Access Compliance Report

Public Rights-of-Way

(Curb Ramps)

Intersection ID: 31959	Main Street: PLANTERS_ESTATES_DR	Cross Street: SKYMASTER_CT	Location: NW
ADA ID: AA25323D4DE7	Ramp Type: PerpDiag	Initial Pass/Fail: Fail	Overall Compliance: No
Severity Score: 21.25			
Codes/Mitigation Info/Possible Solution		Field Measurements/Component Compliance

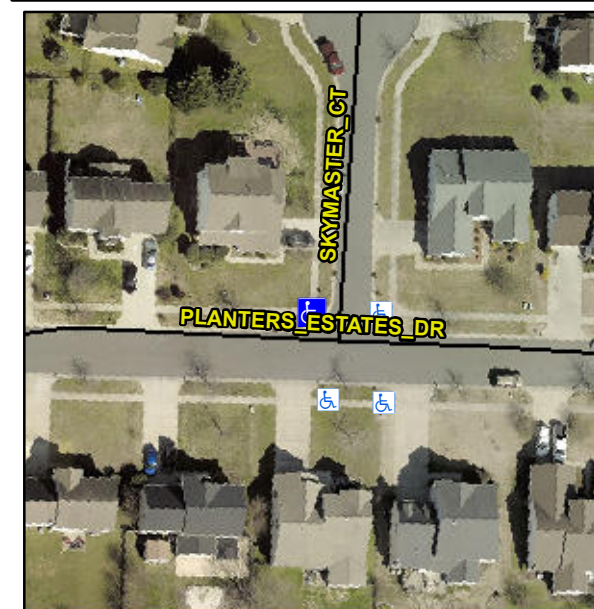
R304.5.1, R304.2.2

Compliance	Description	Data	Compliance	Description	Data
N/A	Ramp Length (in)	41.0	No	Ramp Slope (%)	9.3
No	Ramp Width (in)	44.0	Yes	Ramp XSlope (%)	1.3
N/A	Flare Type LT	N/A	N/A	Flare Type RT	N/A
N/A	Flare Slope LT (%)	N/A	N/A	Flare Slope RT (%)	N/A
N/A	Flare Traversable LT?	N/A	N/A	Flare Traversable RT?	N/A
N/A	Landing Length (in)	N/A	N/A	DWS Provided?	N/A
N/A	Landing Width (in)	N/A	N/A	DWS Contrast?	N/A
N/A	Landing Slope (%)	N/A	N/A	DWS Length (in)	N/A
N/A	Landing X Slope (%)	N/A	N/A	DWS Full Width?	N/A
N/A	Landing Curb? (Y/N)	N/A	N/A	DWS Offset (in)	N/A
N/A	Shared Landing?	N/A			
N/A	Gutter Ponding?	N/A	N/A	Gutter Slope (%)	N/A
N/A	Gutter Lip Ht (in)	N/A	N/A	Gutter X Slope (%)	N/A
N/A	Painted X Walk1?	No	N/A	Painted X Walk2?	No
	X Walk 1 Direction	To SW		X Walk 2 Direction	To SE
N/A	X Walk 1 Width (in)	N/A	N/A	X Walk 2 Width (in)	N/A
	X Walk 1 Slope (%)	3.2		X Walk 2 Slope (%)	0.6
	X Walk 1 X Slope (%)	0.2		X Walk 2 X Slope (%)	0.9

Remove & Replace Curb Ramp With Two New Directional Ramps or Equivalent.
